ARKANSAS POWER & LIGHT COMPANY
POST OFFICE BOX 551 LITTLE ROCK, ARKANSAS 72203 (501) 371-4000
August 31, 1979

Subject: Arkansas Nuclear One-Unit 1
Docket No. 50-313
License No. DPR-51
IE Bulletin 79-14
(File: 2-1510)

IE 79-14 WALKDOWN SUMMARY

SECTION A-A

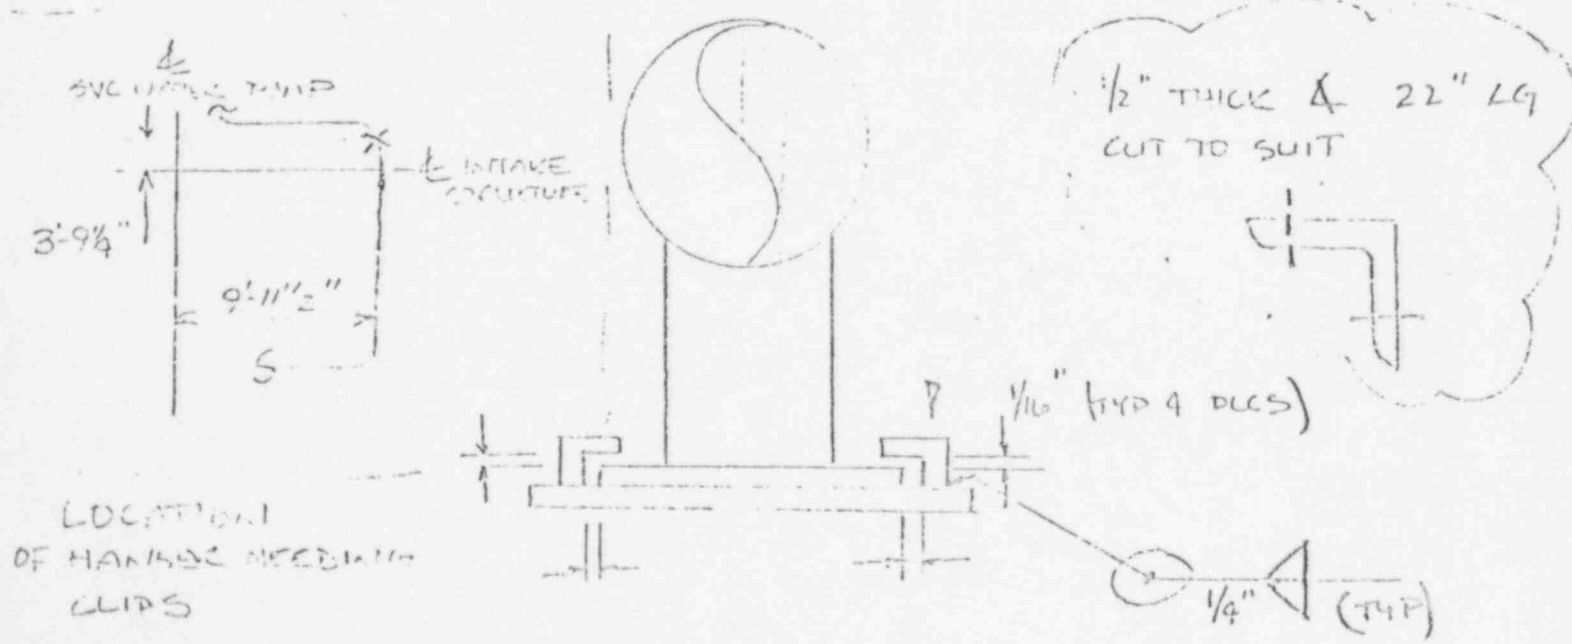
ADD ANGLES TO PROVIDE LATERAL & VERTICAL RESTRAINT
